Field No. HO-1156 Office No. H-8286

Locality Warren Channel

REVIEW OF HYDROGRAPHIC SURVEY

REGISTRY NO. H-8286

Section of
 Chart 8171
 5th Ed. Rev. 1/14/57
 Data from H-8286
 in RED ink.

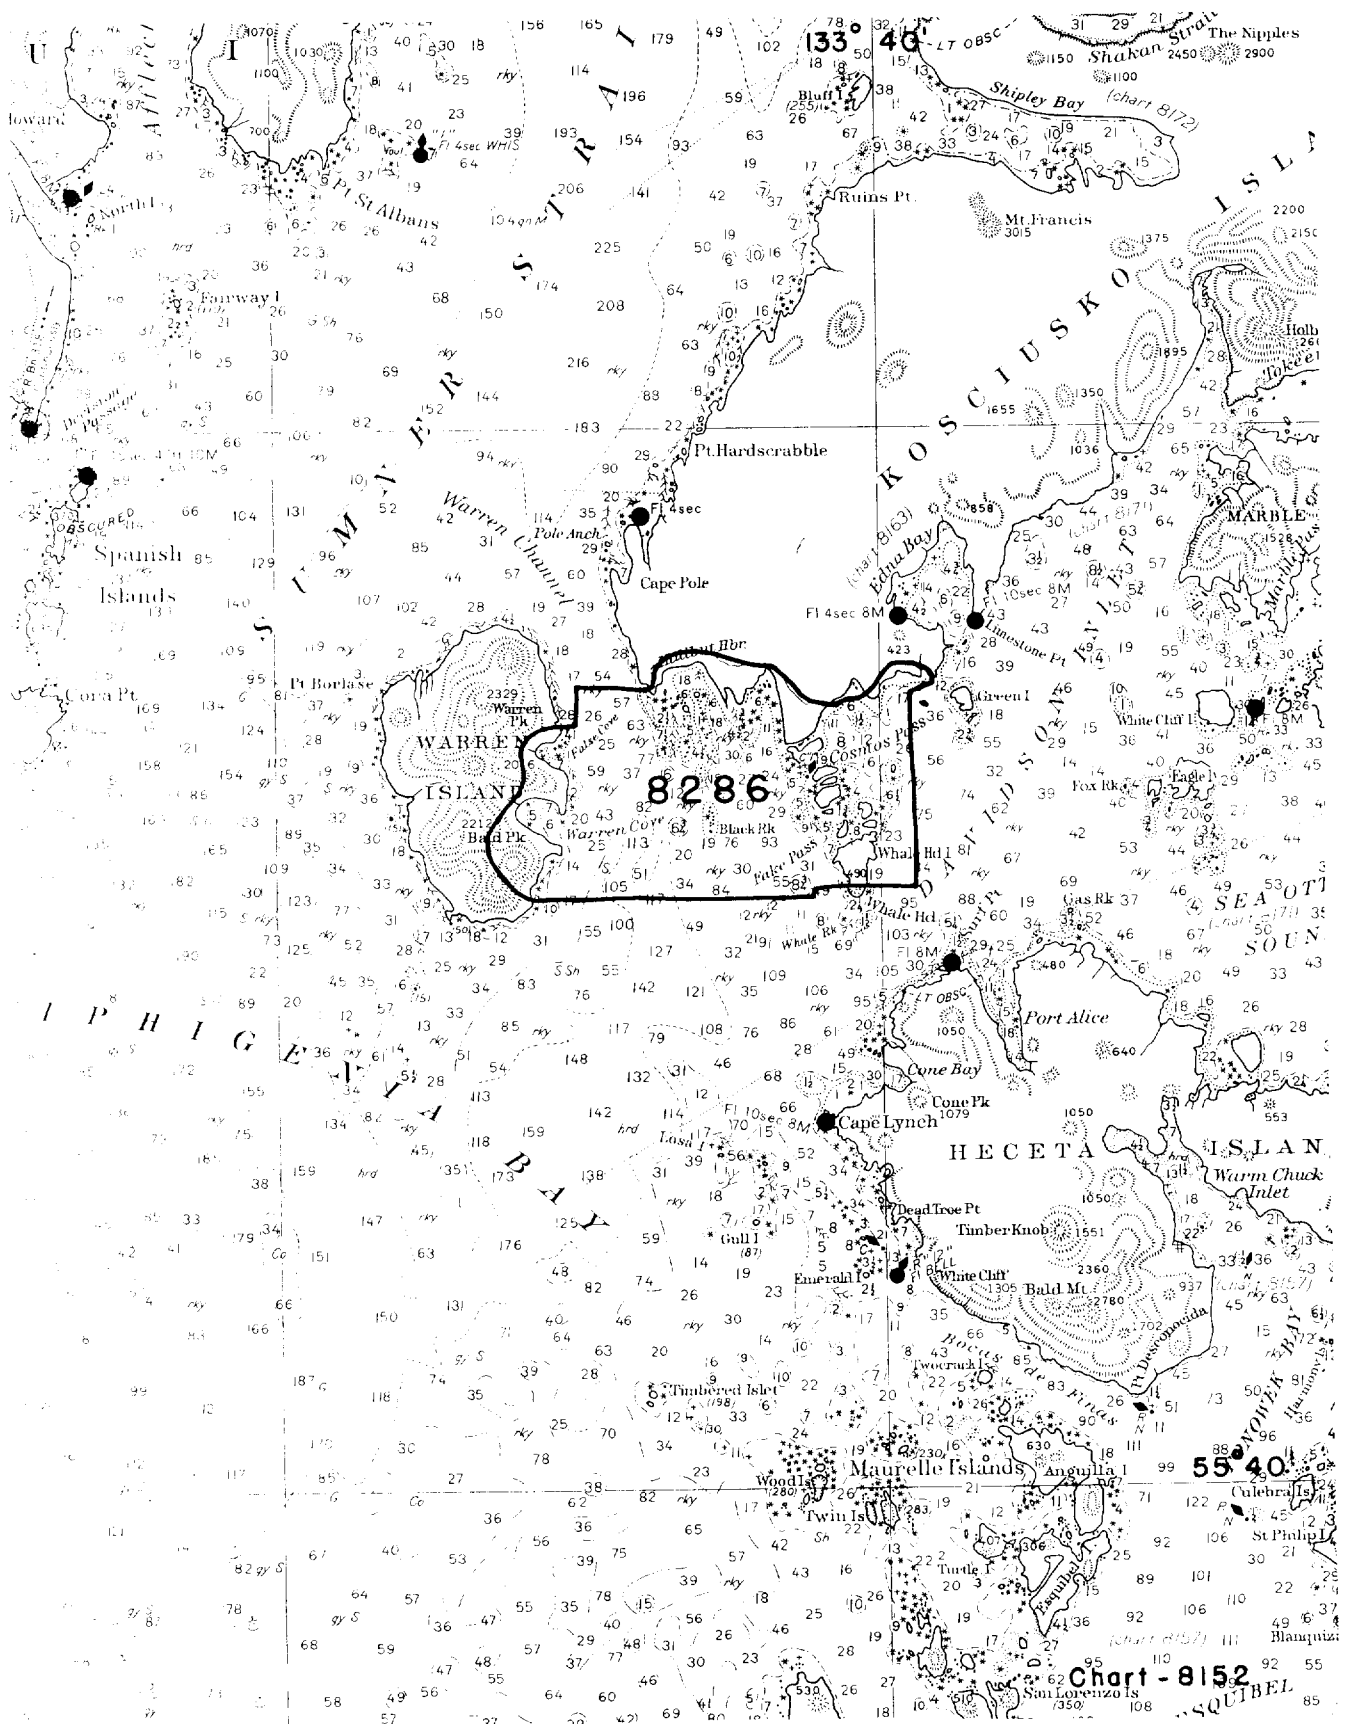
pos. 121-122 "P"
 Vol. 7, P. 45

Approx. 10 fms here
 on smooth sheet.
